FW: Sent from Snipping Tool

Were you able to look at any of the issues and questions below. We really want to get patterns ordered up, but want to makes sure we have all correct. On the 15140 it will be a tear up of design to try and get scrap out on the secondary press. Please let us know so we can keep these projects moving

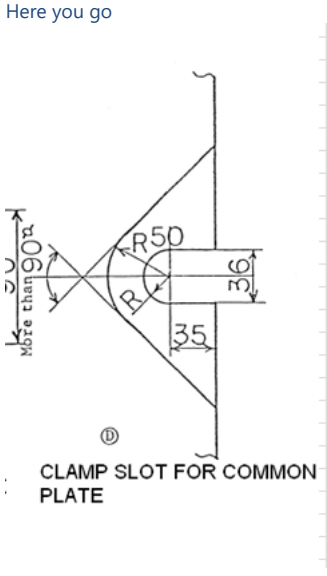
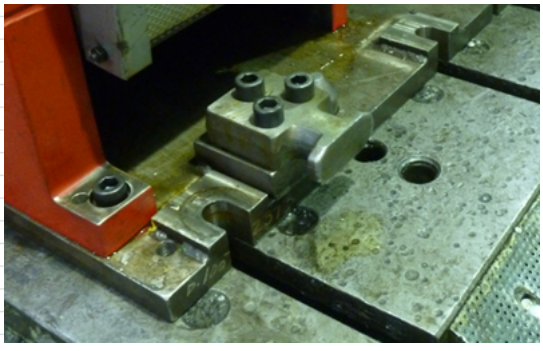
Good Afternoon Gentlemen
What are the dimensions for the Clamp Slot depth and Width?

> **From:** "Nicholson, Craig" <craig.nicholson@kirchhoff-automotive.com>
> **Date:** July 31, 2018 at 8:01:27 AM EDT
> **To:** Patrick Castle <pcastle@toolingsystemsgroup.com>, Ken Smigiel <ksmigiel@toolingsystemsgroup.com>, "Forche, Chris" <chris.forche@kirchhoff-automotive.com>
> **Cc:** Tom Persons <tpersons@toolingsystemsgroup.com>, "Forche, Chris" <chris.forche@kirchhoff-automotive.com>
> **Subject: RE: Sent from Snipping Tool**
>
> Good Morning Patrick
>
> Here you go

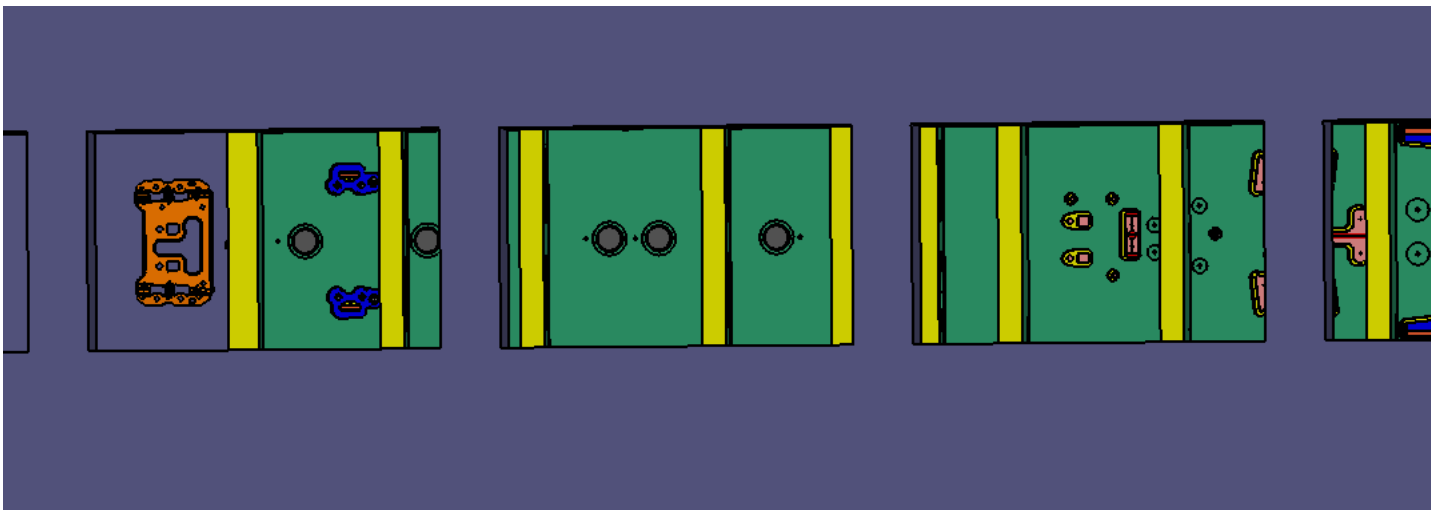
1. Any answers to the press situation below
2. Is there a secondary press for the 15139(ETS5883)
3. Were you able to look at designs and verify any of the following?

Please verify for both jobs

1. Clamping feet upper and lower
2. Shut height and feed height
3. Die locators

Craig, Clamp foot height = 50.8mm. Die set build ht= 1090mm. Passline from top of bolster= 600mm
